# Modification Recommended Service Note

## N8951A - Autoranging System DC Power Supply, 80V, 510A, 15000W, 400 VAC

Serial Numbers: DE14290000 - DE15369999 without manufacturing ID Version "B"

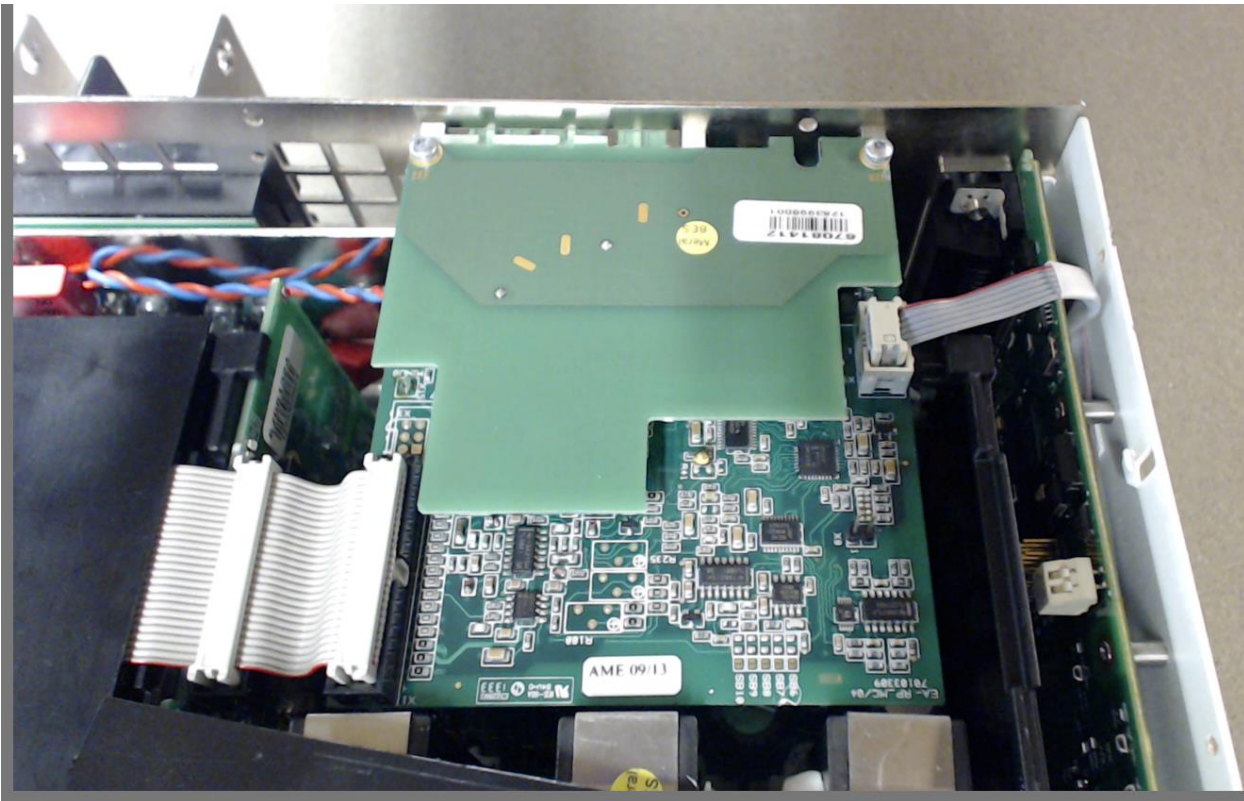
Resistors R93 and R94 must be removed, no replacement parts are required for modification.

5) SMT resistors R93/94 are located in red circle shown below:

Removal of two (2) surface mount resistors, R93 and R94, will correct this problem:

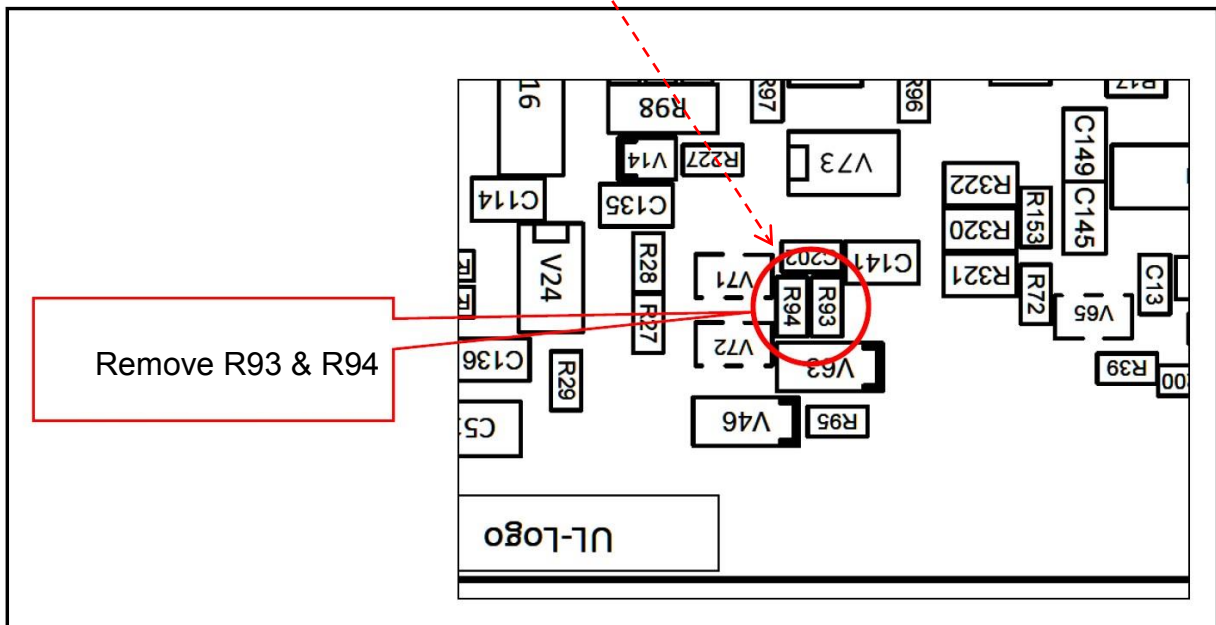
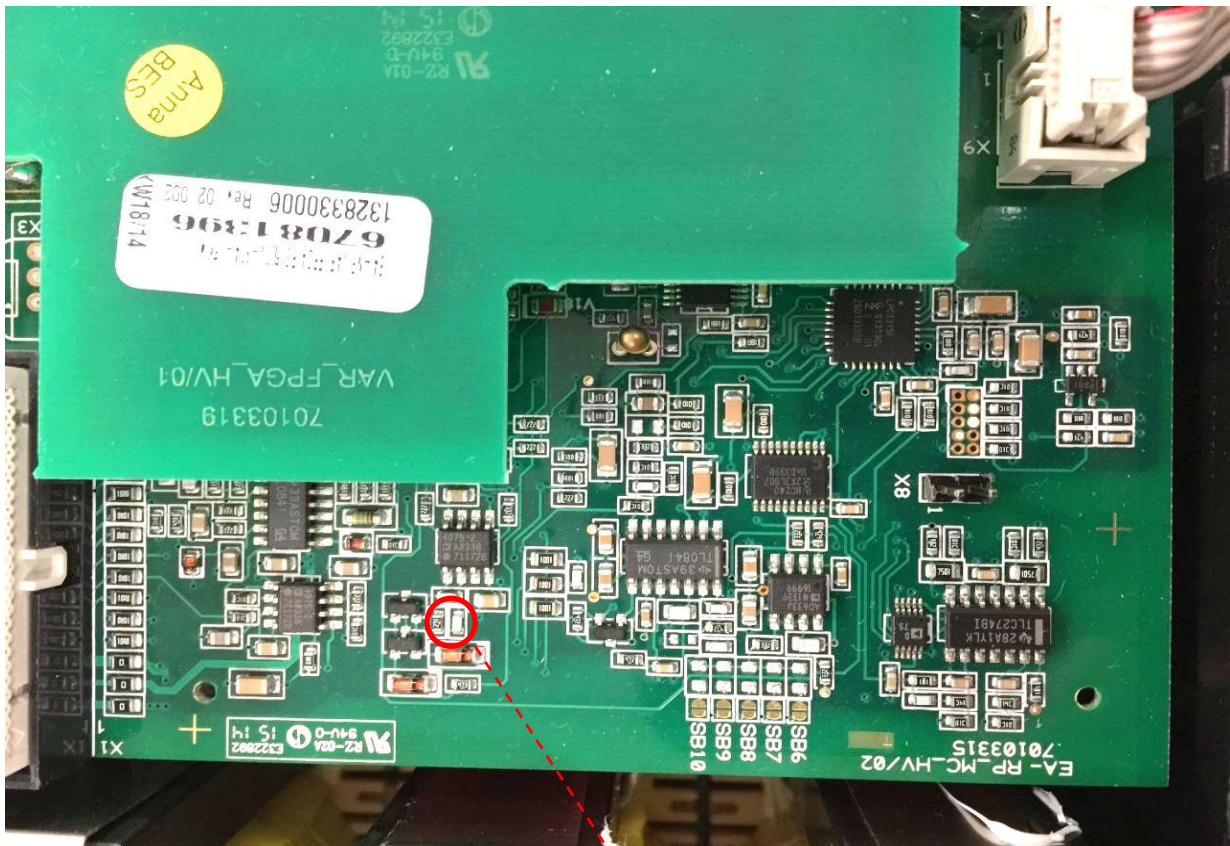
- 1) Remove acMains cable from power source.
- 2) Wait 5 minutes
- 3) Remove top cover from instrument.
- 4) In the 5kW units (viewed from the front of the unit), a small SMT assembly located at the right-rear of instrument will be readily visible (see below):

In the 10kW & 15kW units; although found in the same location, a black plastic cover will have to be removed to gain visibility and access to the SMT assembly. Plastic cover snaps-on and can be removed with a small screwdriver.

Suffix “B” added

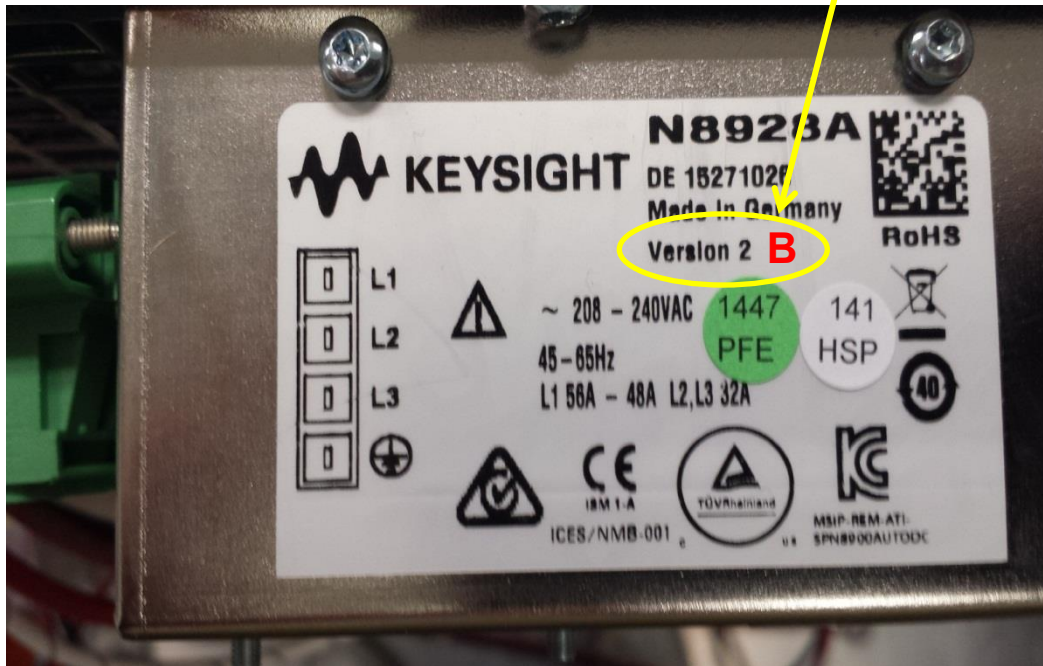
7) On the acMains label, on the rear of the instrument; use an indelible marker, to add the suffix letter “B” after the Version ID. This will assist in the tracking of modified instruments.
